Access Compliance Report Public Rights-of-Way (RR Crossings)

Intersection ID: 14235	Main Street: CAMDEN_RD	Location: N/A
ADA ID: 03D8A2730948	Overall Compliance: No	Severity Score: 0.0
Codes/Mitigation Info/Possible Solution		Field Measurements/Component Compliance

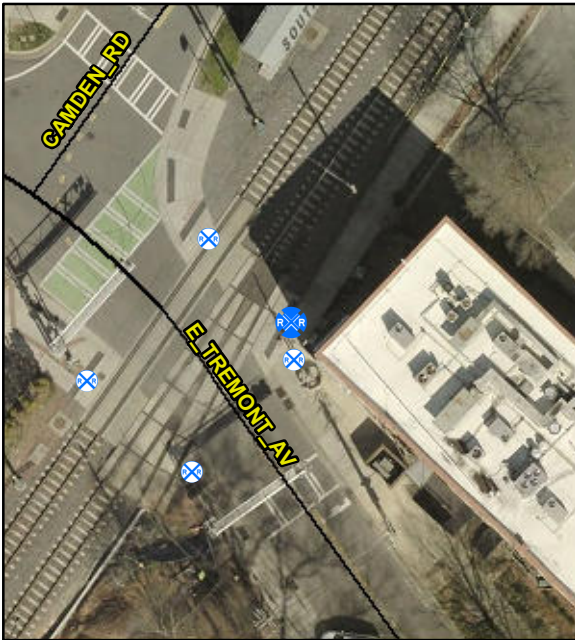
Remove & Replace Detectable Warning System. Provide Pedestrian Gate. Remove & Replace Walking Surface Adjacent to Rail. Remove & Replace Sidewalk.

R302.3, R302.7.4, R305.2.5

Compliance	Description	Data
Yes	DWS Provided?	Yes
Yes	DWS Contrast?	Yes
Yes	DWS Width (in)	Yes
Yes	DWS Length (in)	24.0
No	DWS Offset (in)	39.0
No	Pedestrian Gate?	No
N/A	DWS Outside Gate?	N/A
N/A	Rail Type?	LightRail
No	Flangeway Gap (in)	3.0
No	Sidewalk Width (in)	44.0
